# COBAR CONSOLIDATED RESOURCES LIMITED

Response to Cobar Shire Council  
Request for Additional Information  
Issued on 17 January 2011

## WONAWINTA SILVER PROJECT

March 2011

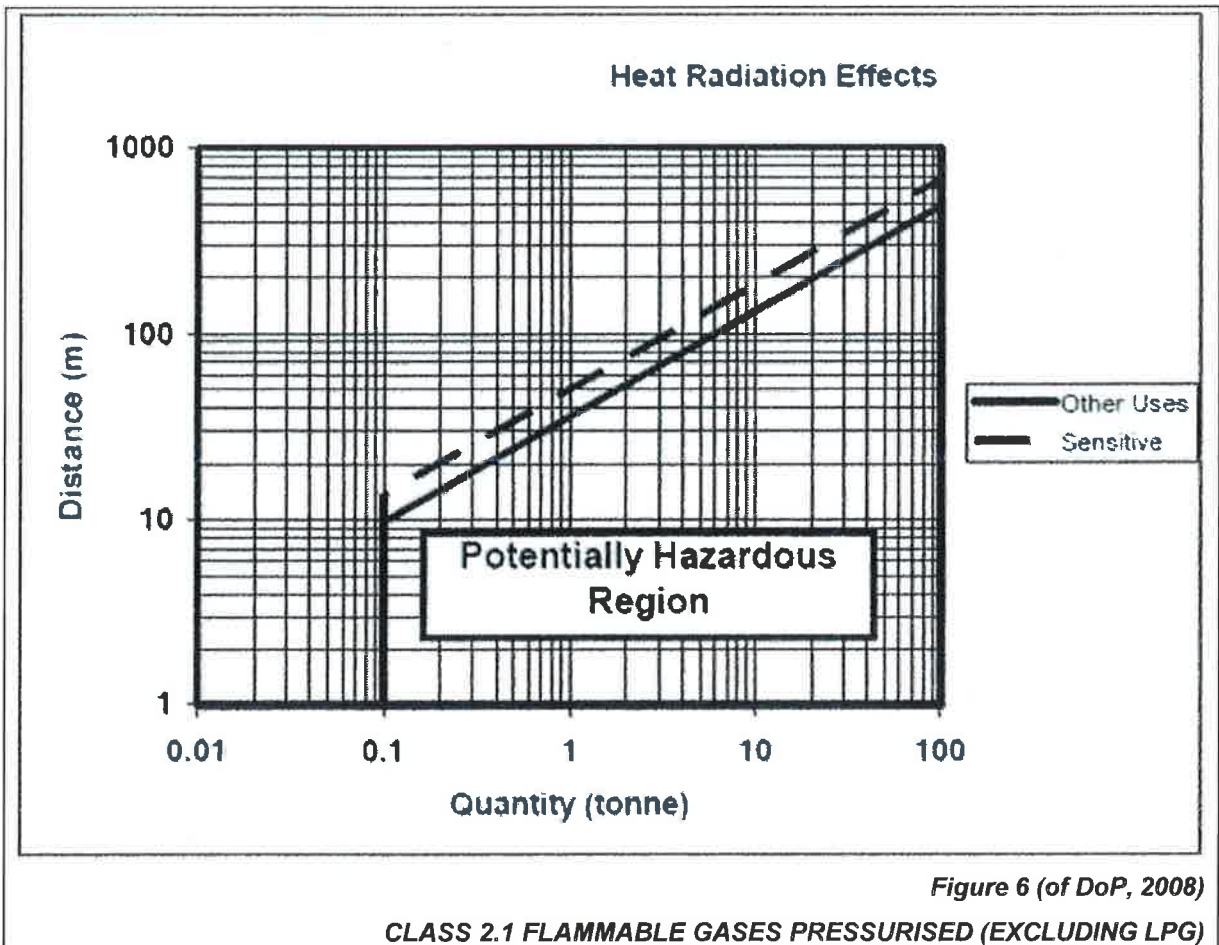
*“The relevant sections of the EIS have not considered risks associated with the project in respect of transporting, storing or handling LPG. The EIS needs to be updated as relevant to SEPP 33 and associated guidelines.”*

Figure 6 of DoP (2008), reproduced below, was used to assess whether the storage of CNG on the Project Site would classify as potentially hazardous industry.

On the basis that less than 100t of CNG would be stored in excess of 1 000m from surrounding land uses, this does not classify as Potentially Hazardous Industry and a Preliminary Hazard Analysis (PHA) is not required.

Figure A  
 MODIFIED MIRRABOOKA WATER  
 PIPELINE ROUTE ALIGNMENT

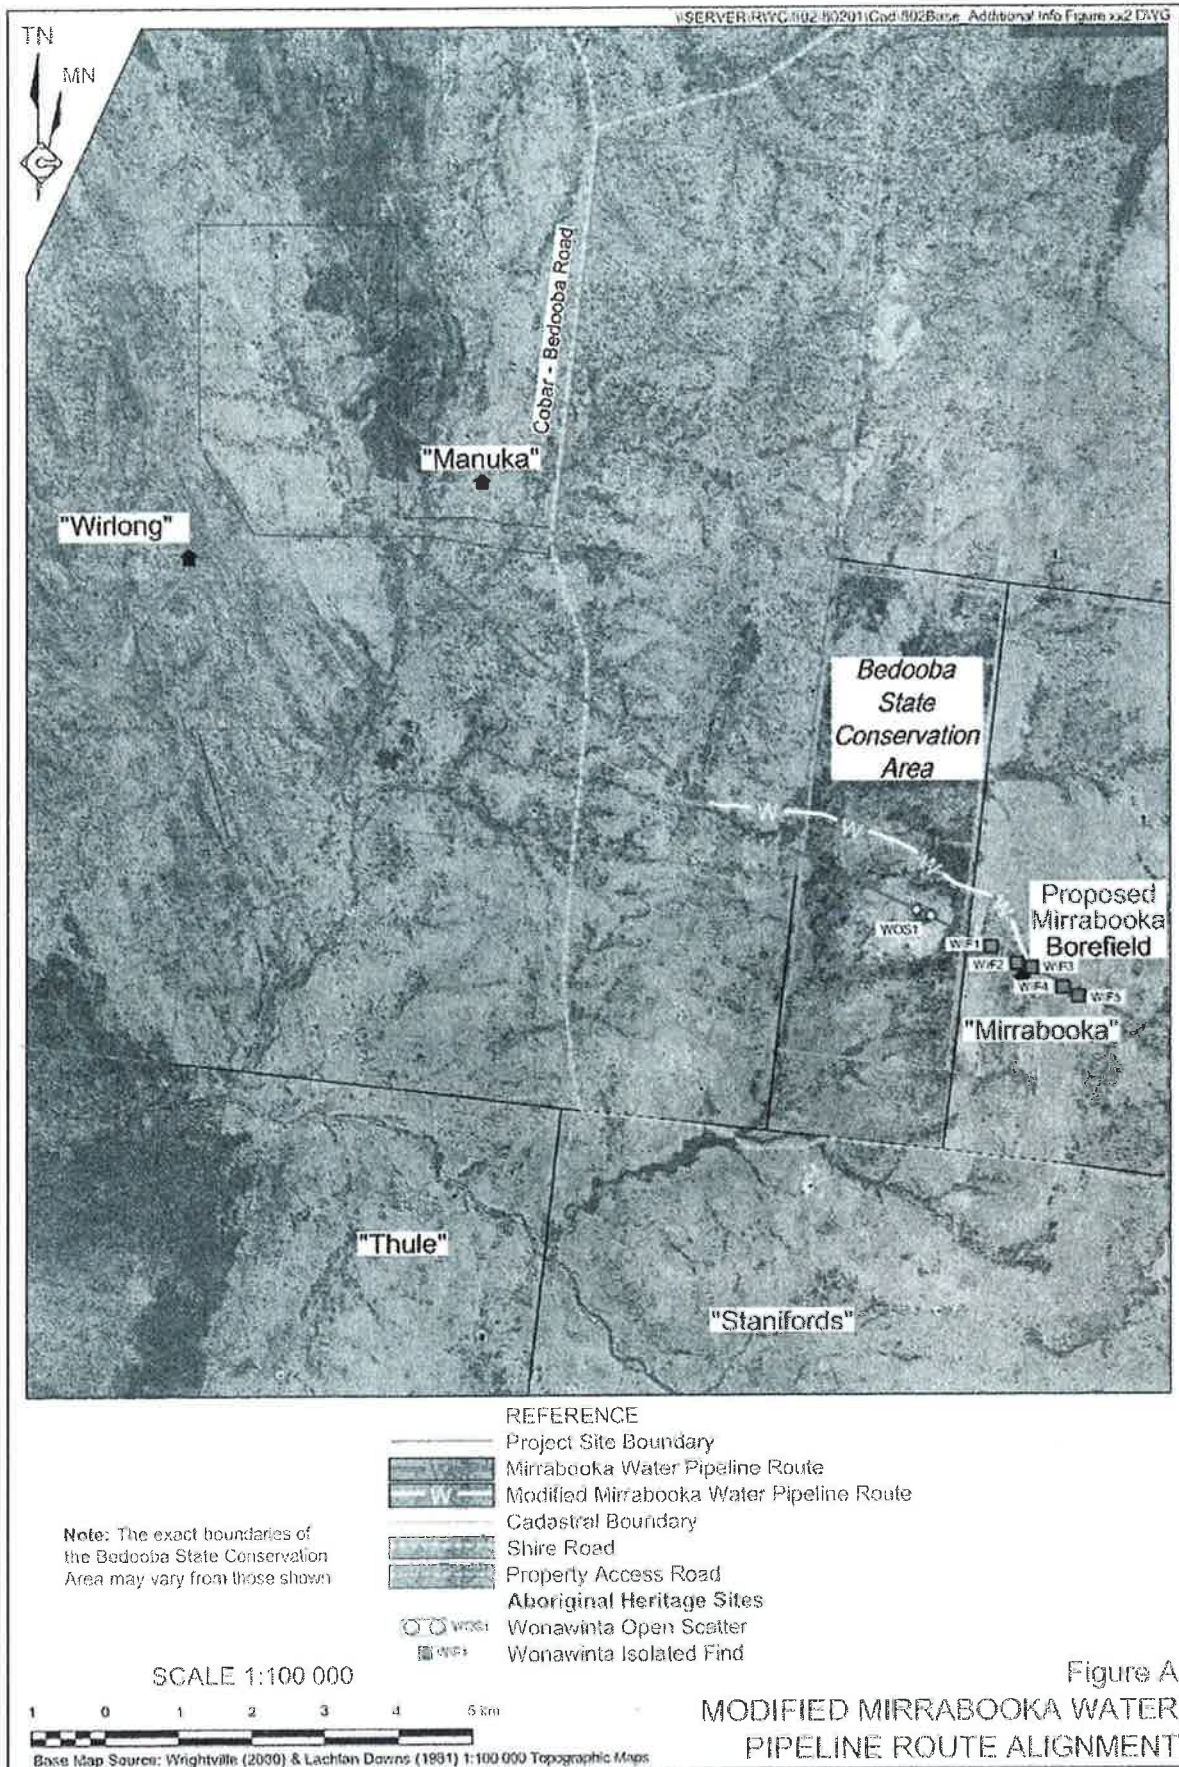
- i. The reservation of the former Bedooba State Forest No.888 as a state conservation area on 1<sup>st</sup> January 2011.*
- ii. Details of the proposed booster pump station to be installed in the "Cobar-Bedooba Road" reserve. Sufficient detail is required to enable the potential impacts on the operation of the road.*
- iii. Relevant documentation to demonstrate that the proposed easements are possible and likely to be obtained.*
- iv. Justification to support the final selection of the proposed pipeline routes.*

With a view to identifying an alignment through Bedooba SCA, which would result in minimal environmental impact, Mr Phillip Cameron (of OzArk Environment and Heritage Management ["Ozark"]), who conducted the ecological assessment of the Project Site and water pipeline routes, was consulted. Mr Cameron advised of a cleared and maintained road (which acts as a secondary to the homestead on the "Mirrabooka" property). **Figure A** identifies the original alignment of the Mirrabooka Water Pipeline Route through Bedooba SCA, and the alignment of the existing "Mirrabooka" homestead access road.

Given the occurrence, and requirement as a secondary access to Bedooba SCA and the "Mirrabooka" homestead, the Mirrabooka Water Pipeline Route would be realigned to use this road. To ensure that any impact is minimised, the pipeline would be placed immediately below the road surface with disturbance required in the placement of the pipeline confined to the existing cleared surface of the road.

It is noted that, with the exception of the modified alignment of the water pipeline through Bedooba State Conservation Area (SCA) (see **Figure A**), the alignment does not make use of the Cobar-Bedooba Road easement, or access road between Cobar-Bedooba Road and the "Mirrabooka" homestead. This is justified on the basis that the very small amount of vegetation to be disturbed, does not represent threatened or regionally significant vegetation. Therefore, there is little environmental gain to be made for the additional cost associated with the additional pipeline length and deviation required.

Importantly, however, by modifying the alignment of the proposed water pipeline through Bedooba SCA (to utilise an existing access road), impact to the vegetation of better condition (which is now to be conserved under the management of the Department of Environment, Climate Change and Water) would be avoided. Furthermore, by realigning the pipeline route through Bedooba SCA, Aboriginal site WOS1 would be avoided.
